Agreement No. CE 82/2022 (WS)
In-situ Reprovisioning of Tsuen Wan Water Treatment Works – Investigation, Design and Construction
Further Information of S.16 Application

Further to S.16 Planning Application No. A/TW/549, we would like to enclose the following documents for further information of the S.16 Application:

Responses to Comments

Drawing Title
MASTER LAYOUT PLAN WITH OUTLINE ZONING PLAN

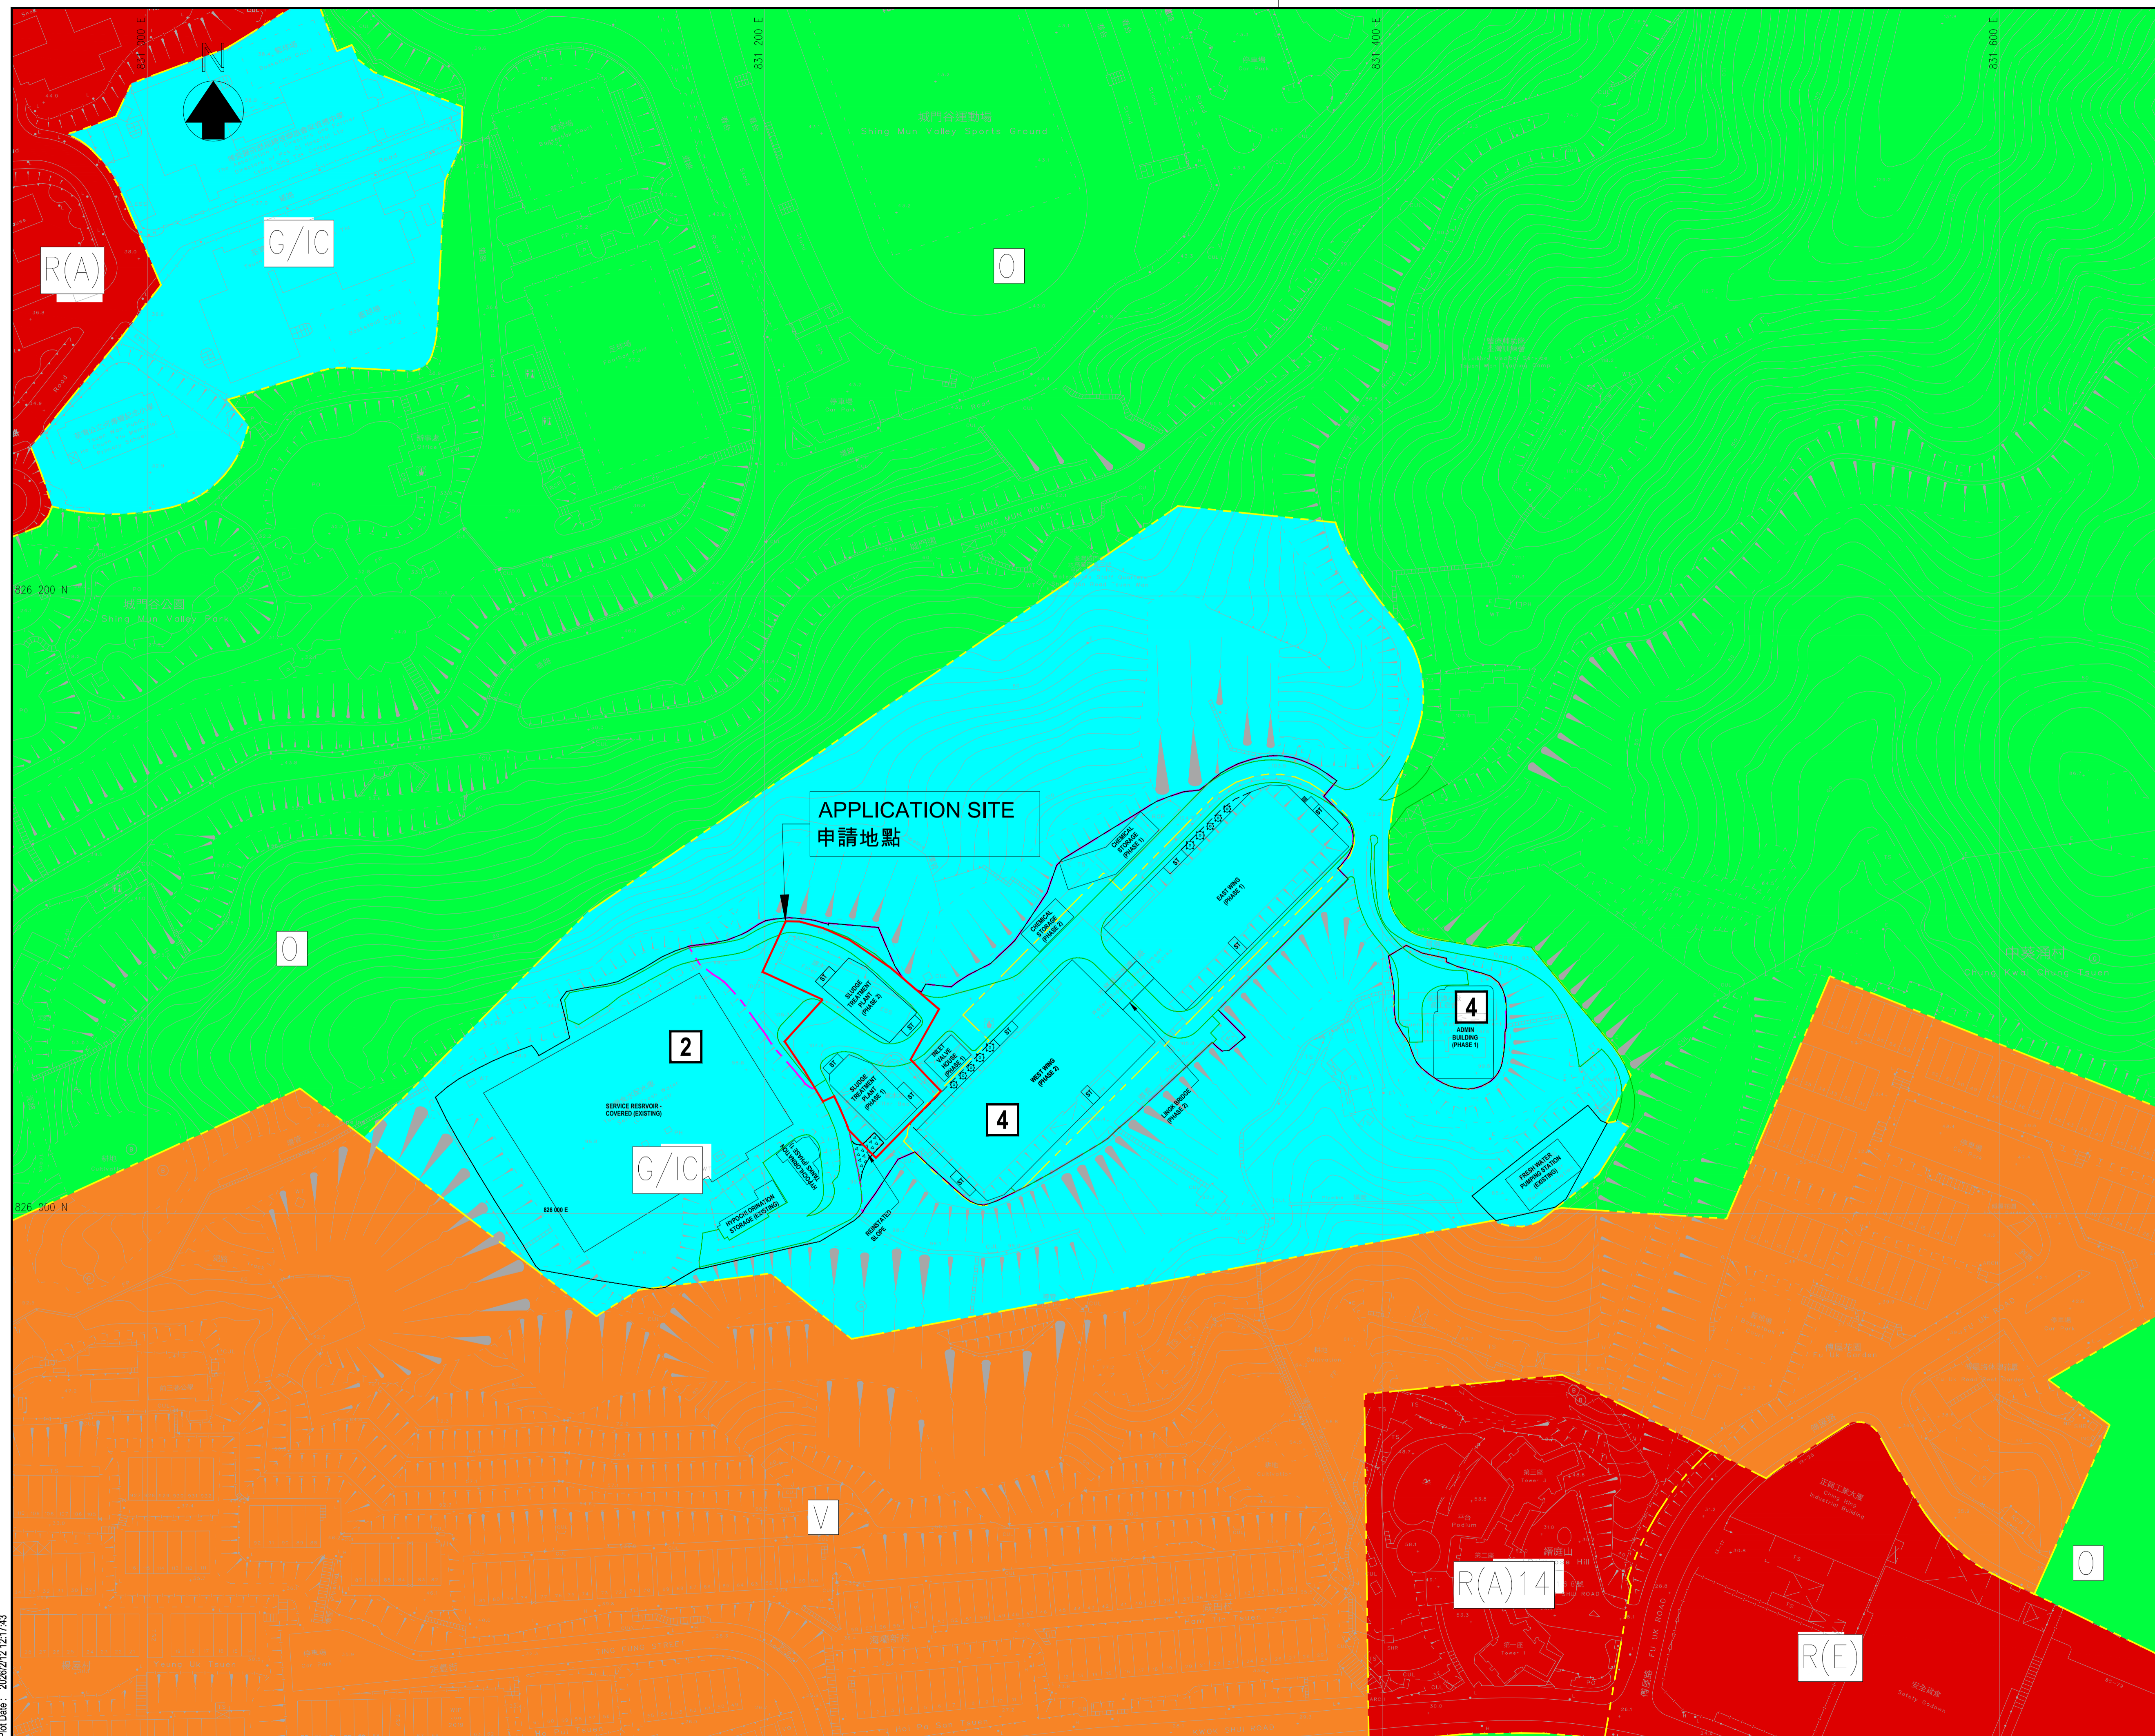
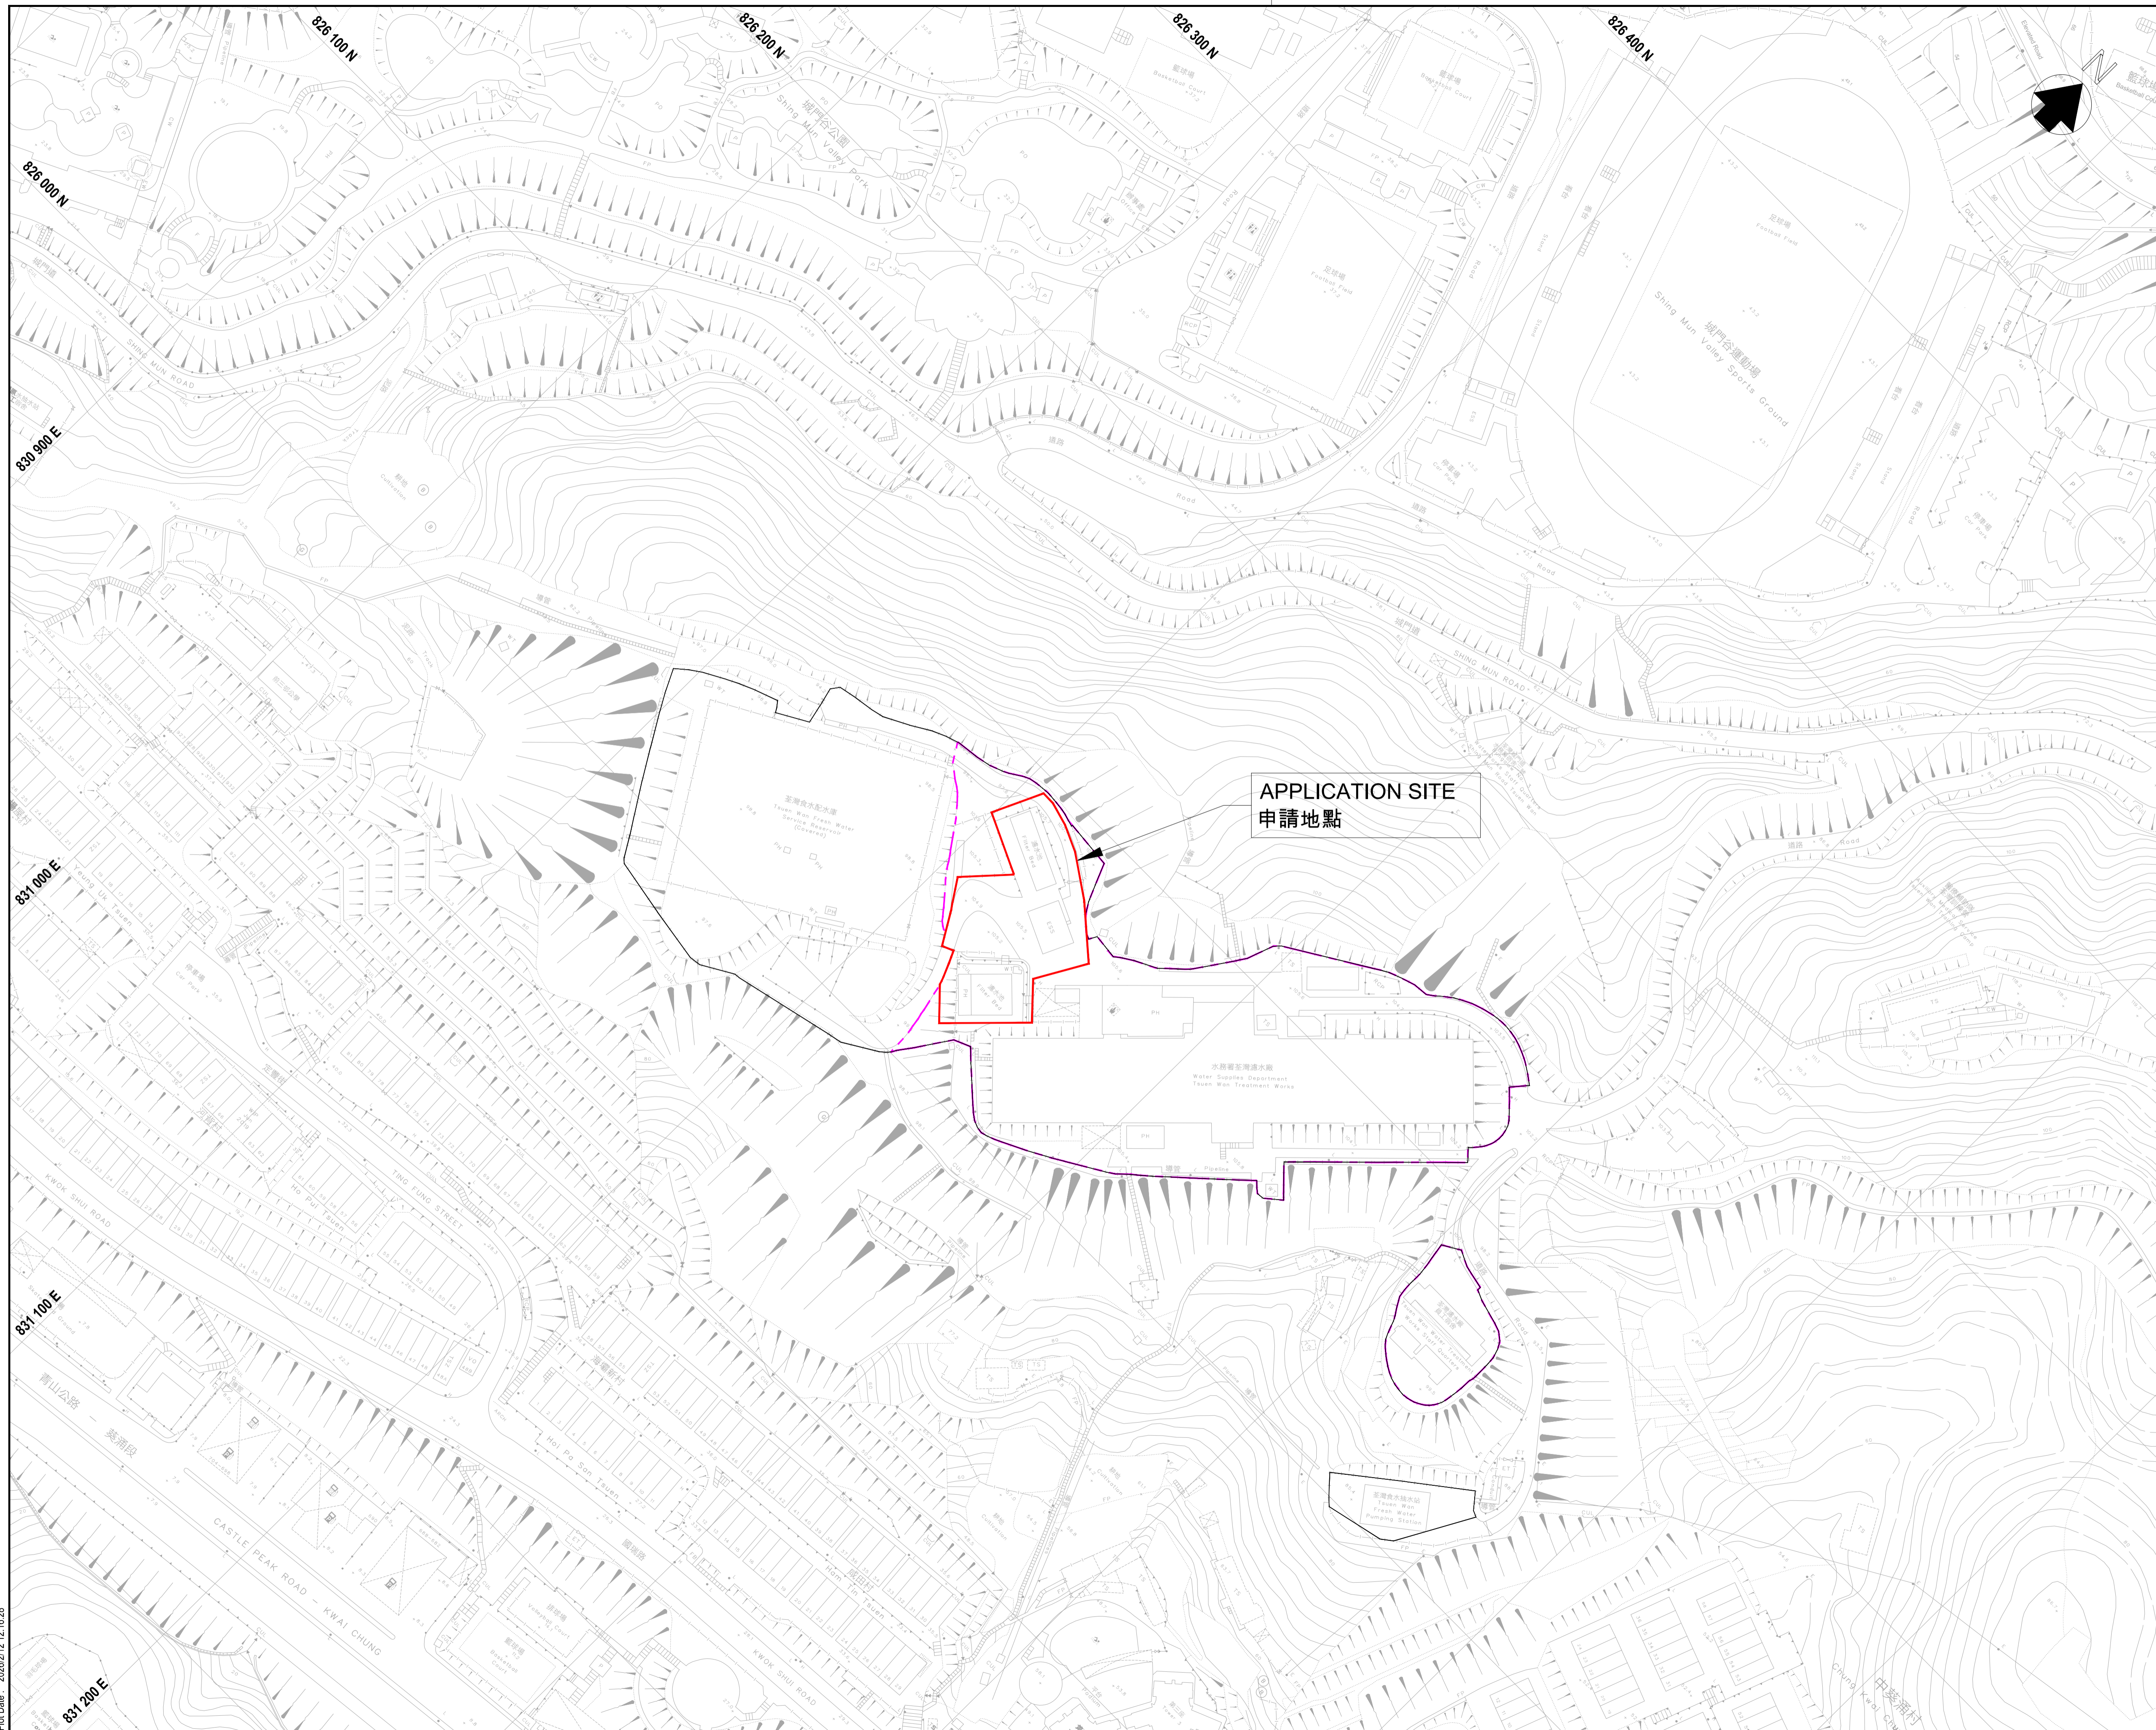
Planning Statement - Section 3.1.8	(b)(iii). It is noted that the consultant proposed "Landscape features are designed to achieve maximum convenience and efficiency for the usage of water treatment works areas ...Photomontages of the overall Proposed Development is provided in Figure 36 to 40." However, the stated landscape features could not be found in the mentioned figures. The proposed landscape feature should be indicated in a landscape plan for reference.	Clause 3.1.8 is revised below "...Photomontages of the overall Proposed Development is provided in Figure 22." (revised to A4 size)
Planning Statement - Section 4.3.3.2	(b)(iv). Please refer to comment item (b)(ii) above and review accordingly.	As there is no tree felling, clause 4.3.3.2 is revised. We would also like to clarify the status of the GLA is proposed. Relevant replacement drawings are attached.
